Amendments to the Drawings:

Attachments: Replacement Sheet

Fig. 3A

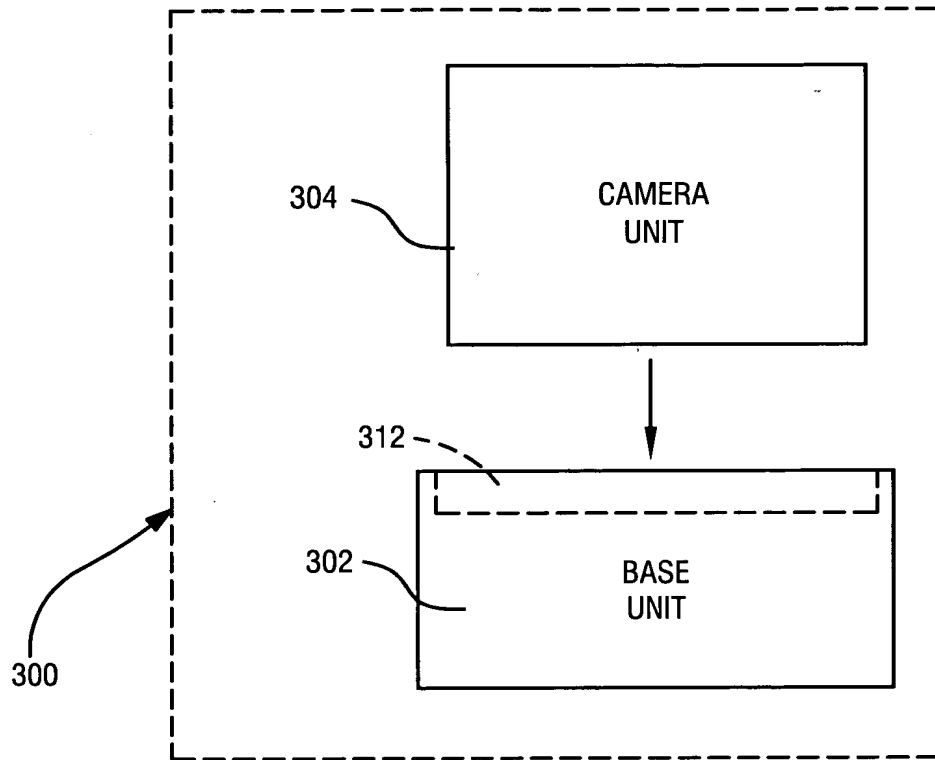
The attached sheet of drawings (1) re-labels Figure 3 as Figure 3A; (2) adds a slot 312 to the base unit 302 shown in re-labeled Figure 3A; and (3) adds a new Figure 3B showing camera unit 304 remotely located from the base unit.
